**Reference: Lannan Road - Response to Comments on Master Plan Resubmissions
Parks Master Plan Responses**

LANNAN PARKS MASTER PLAN

Lannan Road Development – Proposed Rezoning – Zoning Amendment Bylaw 2973

Revised and resubmitted May 9, 2025

L1

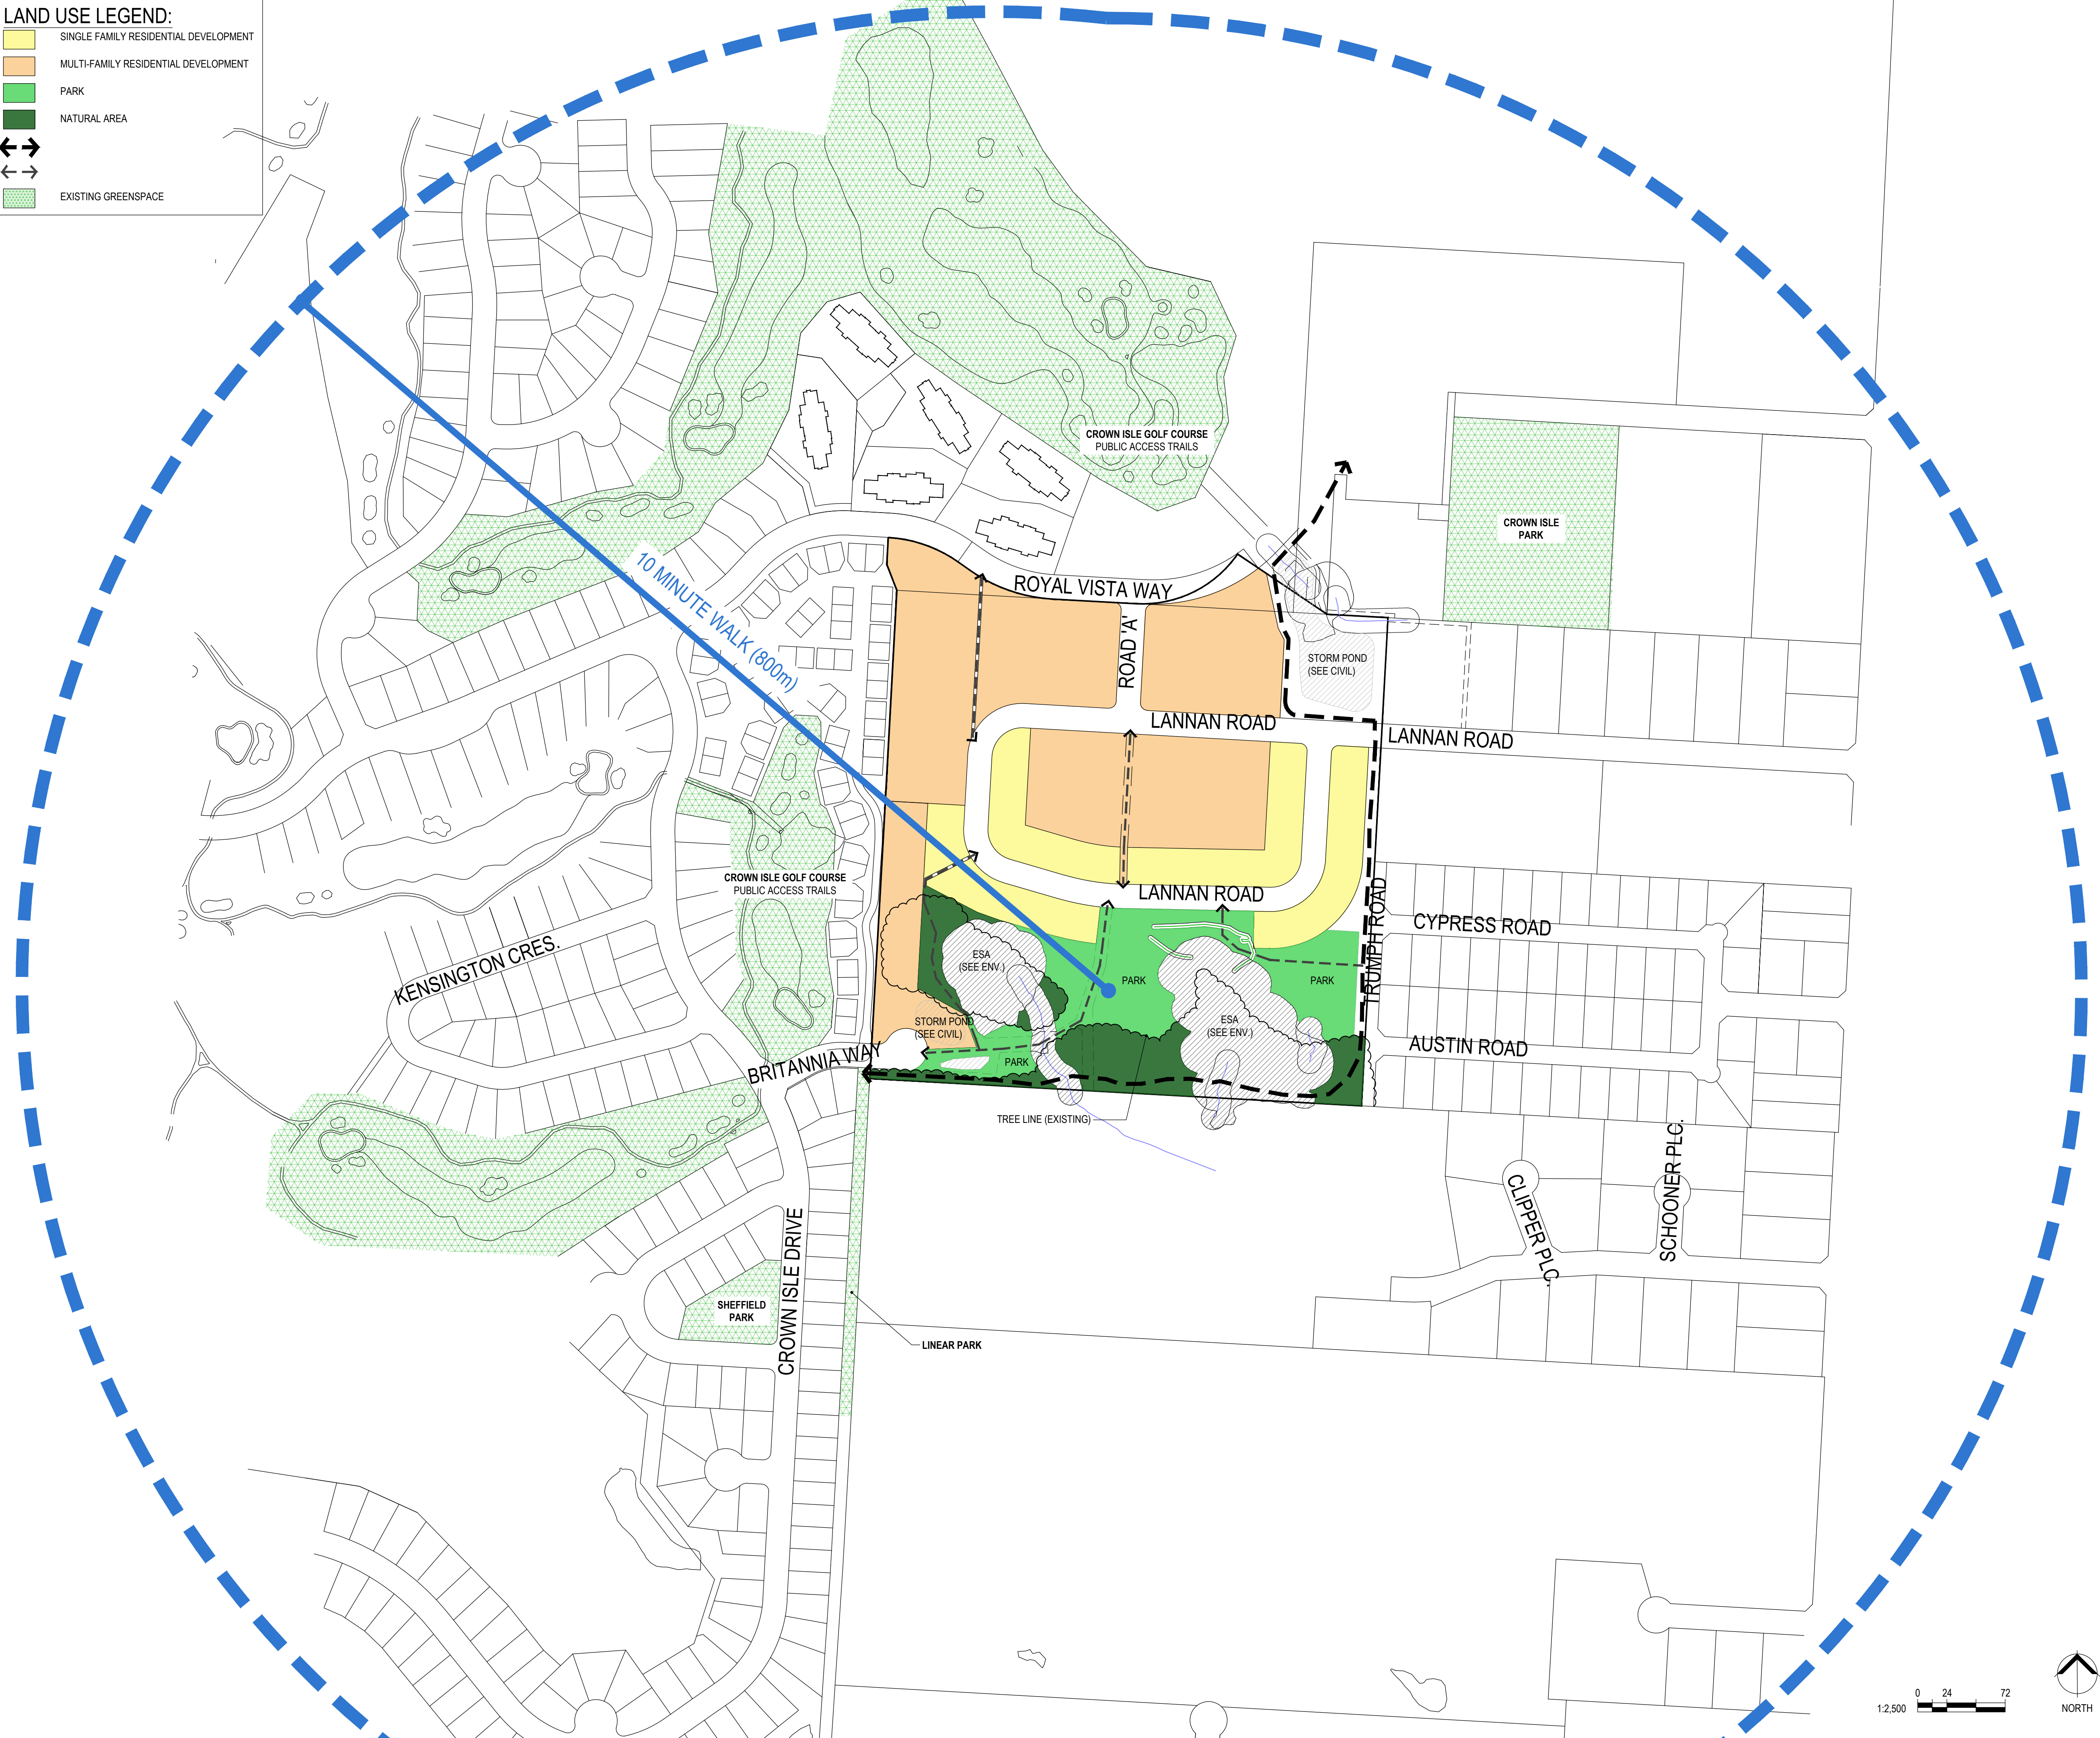
- 50. **‘L1 – Key Plan’** now shows an 800m radius, centered on the proposed Community Park. In addition to this park, which is within 400m walking distance of all future residents of the development, there are two (2) Neighbourhood Parks in the area: Sheffield Park to the southwest and Crown Isle Park to the northeast. Further, the multi-family developments will contain private outdoor common spaces which will expand access to the outdoors for residents in these areas. These will be developed during detailed design.
